Project : Renos & Additions to Northern
Address: Lebanon Middle & High School

Change Order No: 25

To provide Door Access and Hardware revisions associated with ASI-17. This change order is for the Sage Equipment and devices portion of ASI-17. See the attached McCarty revised COR EC-61RA (8733RA) dated July 31, 2024. Also included as back up documentation is the original ASI-17 cover page identifying all doors included as part of this ASI, CRA's 7-17-24 email showing reduction in the number of doors to be excluded, the original McCarty COR EC-61 and 61R which have since been revised.

ARCHITECT'S SUPPLEMENTAL INFORMATION – ASI #17

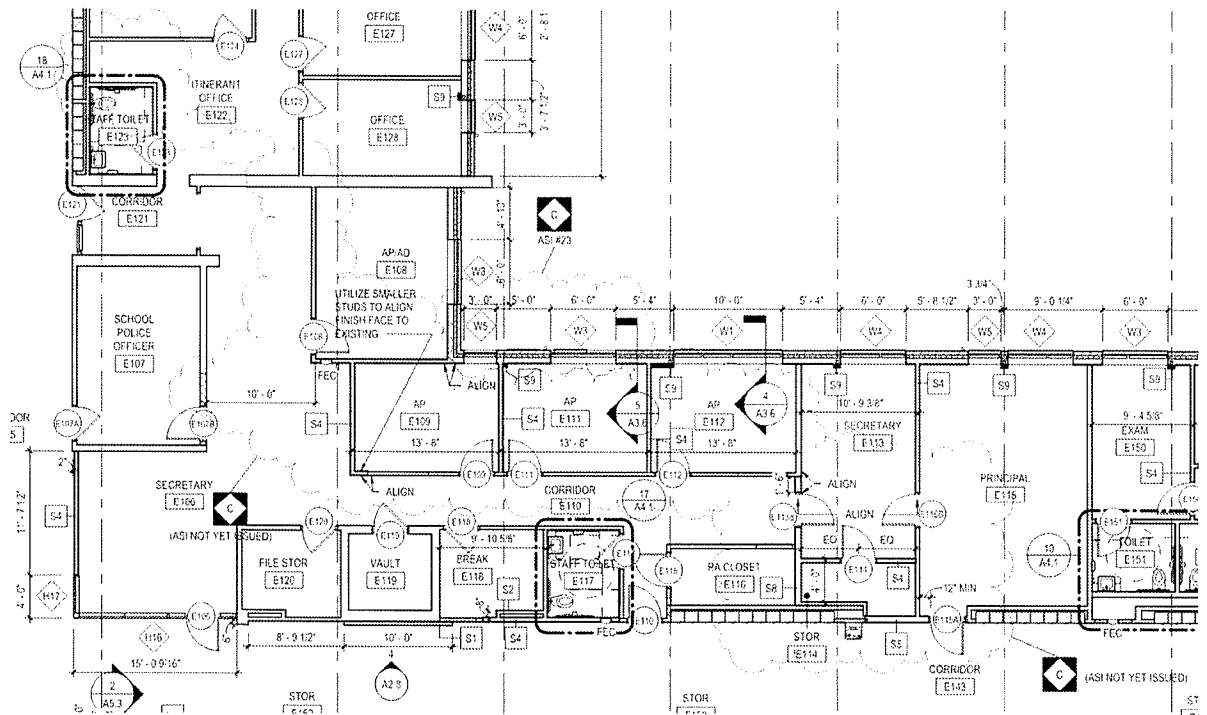
- This ASI contains revisions to door access and door hardware.
- There are also updates to the door schedule to capture mark-ups in returned door/frame shop drawings.
- As a note, the revisions also include doors and frames related to a forthcoming separate ASI. Please include the doors and frames in this ASI, to expedite the door/frame procurement. For context, below is a snip of the forthcoming layout adjustment in a future ASI:
